# **Rebuttal Report to Jones and Mayo (2017)**

**PRESENTATION TO THE OFFICE OF THE NEVADA STATE ENGINEER**

Pertaining to:  
Groundwater Applications 54003 through 54021 inclusive  
and  
53987 through 53992 inclusive

**Figure 1**  
**ET Discharge and Transitional Storage Captured by ET-Capture Wells as a Function of Time**

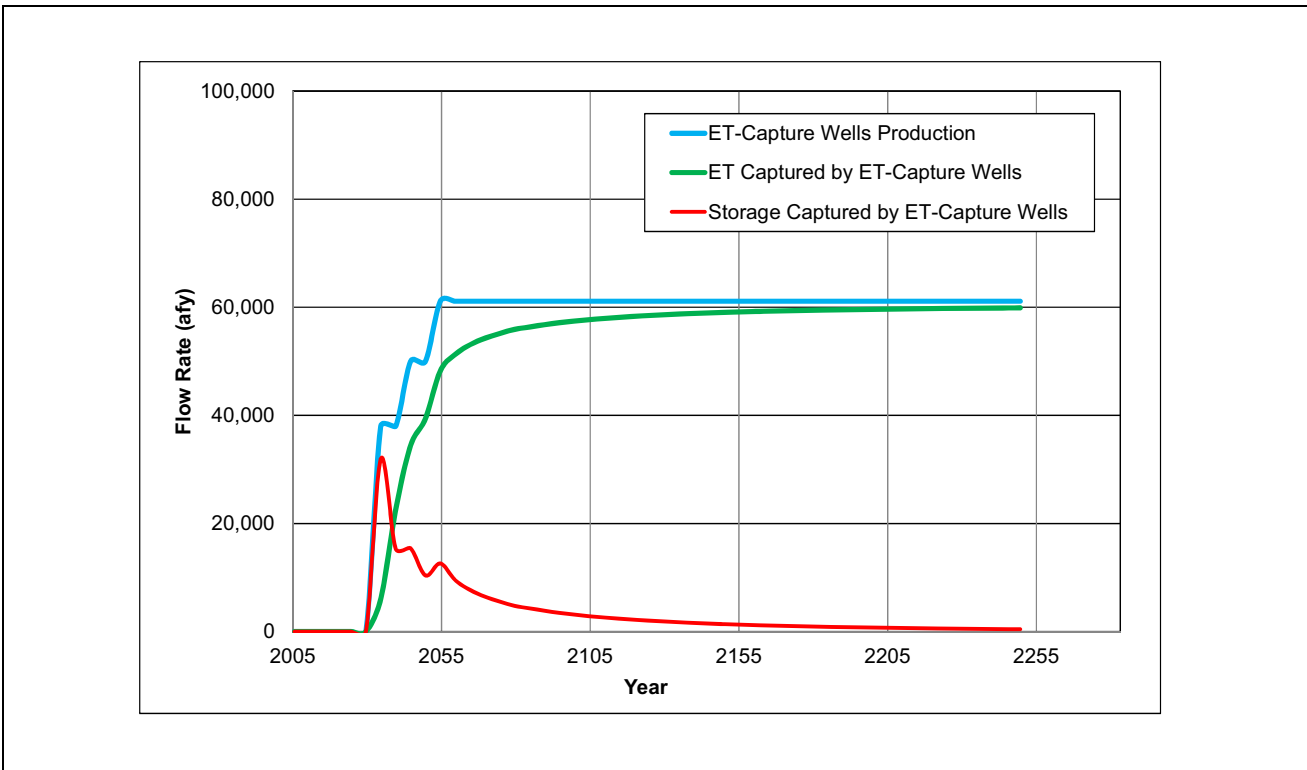
The results of the model simulations regarding time to equilibrium can change dramatically by simply altering the placement of wells in the simulation. Drici et al. (2017) demonstrated that by simply changing the well configuration, 98 percent of the approved project water can be produced from ET salvage within as little as 75 to 200 years (Figure 1). This further demonstrates that if ET capture is

**Figure 2**  
**Figure 5-8 (Modified) from Jones and Mayo (2017)**

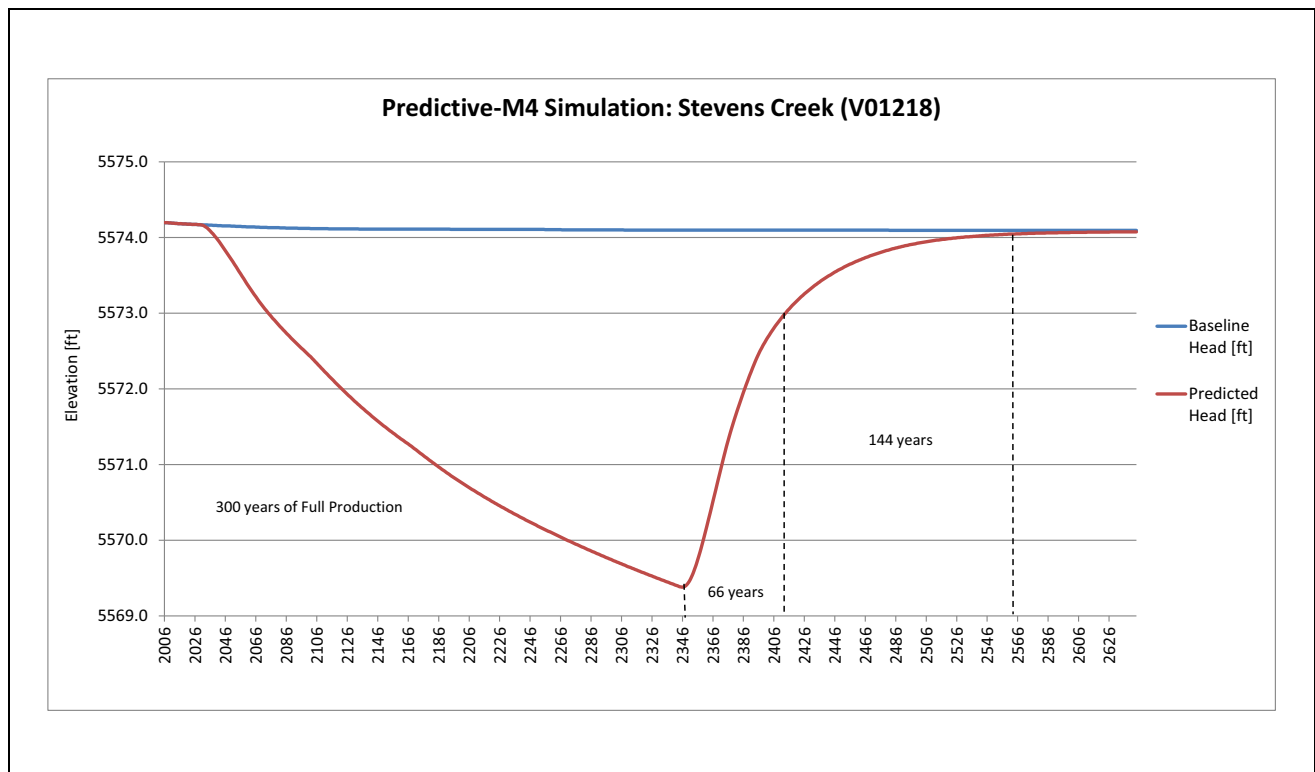
- Jones and Mayo (2017) also contains a rebound analysis, which they characterize as an analysis to see how Spring Valley aquifers would “rebound” (p. 36) after pumping stops. To perform this analysis Jones and Mayo (2017) simulated 300 years of groundwater production followed by 300 years of no pumping. In this simulation, ET and water levels returned to their pre-pumping levels prior the end of the simulation. Jones and Mayo interpret the results of their rebound analysis in a misleading manner.

The primary takeaway from this analysis, as shown on [Figure 2](#), should have been that water-level recovery initially occurs rather quickly, but that full recovery may require the same amount of time as it takes for the drawdowns to initially occur. Rather than doing a 600-year simulation, Jones and Mayo could have just as easily demonstrated that, with a year of production related drawdowns, it would only take a year for full recovery. Jones and Mayo arbitrarily chose a 600 year simulation period with 300 years of pumping, thereby impacting the usefulness of their results.

A more detailed look at the data supporting the figure used in Jones and Mayo (2017) shows that after 300 years of groundwater production and drawdowns, all but the last foot of drawdown recovers within as little as 66 years of no pumping. It is the final foot of recovery that requires an additional 144 years to recover. Under this simulation, it only takes 210 years to fully recover from 300 years of full production ([Figure 2](#)).
